Work Order ID 99616

D3290-041 REPLACEMENT WINDOW ASSEMBLY

DRAWING NO. D3290	TITLE REPLACEMENT WINDOW ASSEMBLY	REV. C	DART AEROSPACE LTD ENGINEERING ORDER		D.E.O. NO. D3290-C-1	SHEET NO. SHEET 1 OF 1	SCALE NTS
DRAWN <i>Q</i>	CHECKED <i>h</i>	MFG. APPR. <i>E</i>	APPROVED <i>MP</i>		DE APPR. <i>#</i>		
DATE 09.09.18	DATE 09.09.18	DATE 09.09.18	DATE 09/09/21		DATE 09/09/21

D3290-1 FRAME

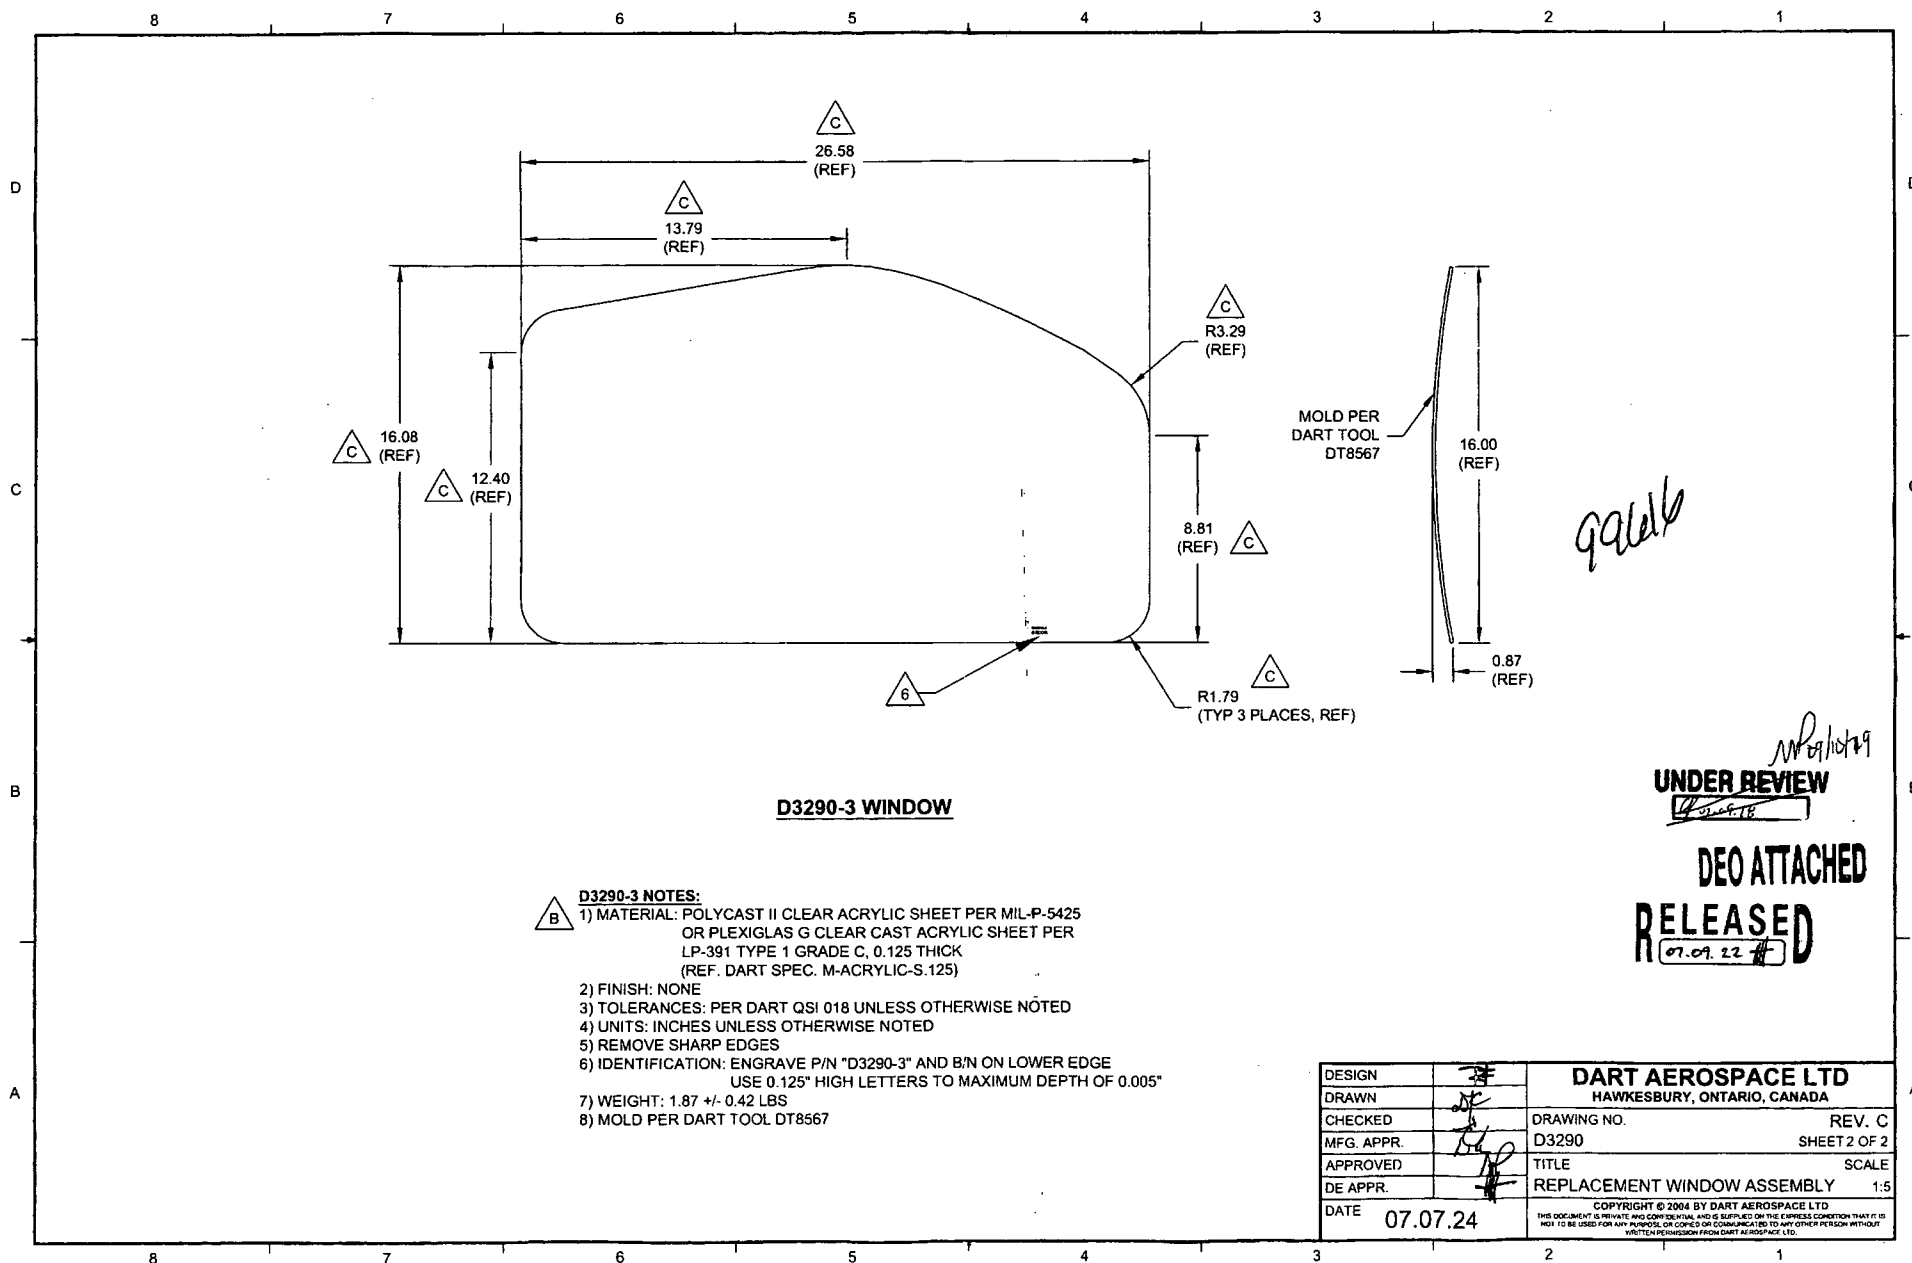
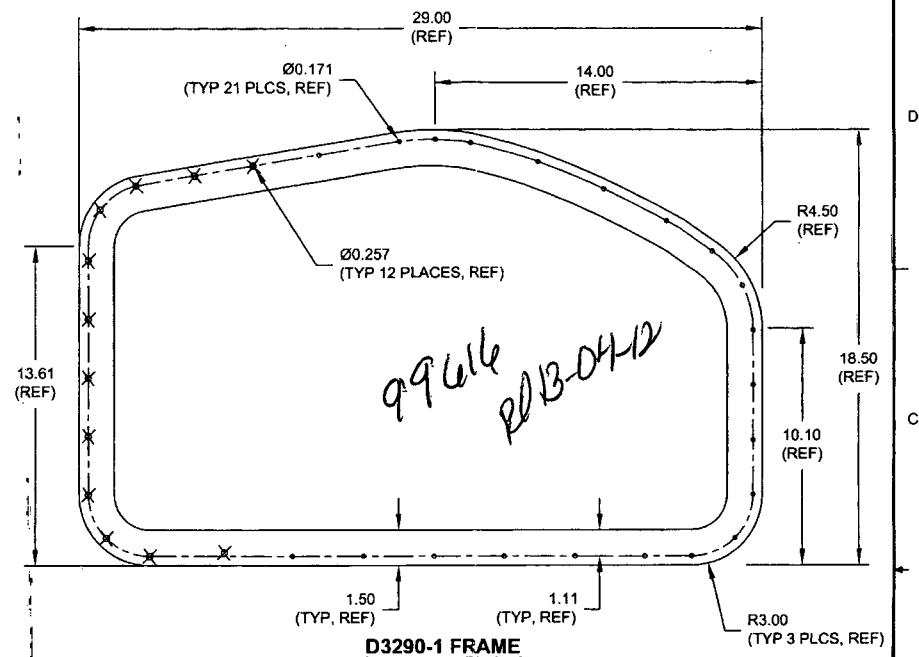
PURPOSE:

CHANGE MATERIAL THICKNESS OF D3290-1 FRAME TO 0.063 FROM 0.040. REF PAR 09-033.

MATERIAL CALL-OUT OF D3290-1 FRAME ON SHEET 1 IS AMENDED AS FOLLOWS:

- 1) MATERIAL: 6061-T6 (OR 6061-T62) ALUMINUM SHEET ~~0.040 THICK~~ 0.063 THICK (REPLACE)
 PER AMS-QQ-A-250/11 OR AMS 4025 OR AMS 4027
~~(REF. DART SPEC. M6061T6S.040)~~ REF. DART SPEC. M6061T6S.063 (REPLACE)
 OR
 5052-H32 ALUMINUM SHEET ~~0.040 THICK~~ 0.063 THICK (REPLACE)
 PER AMS-QQ-A-250/8 OR AMS 4016
~~(REF. DART SPEC. M5052H32S.040)~~ REF. DART SPEC. M5052H32S.063 (REPLACE)
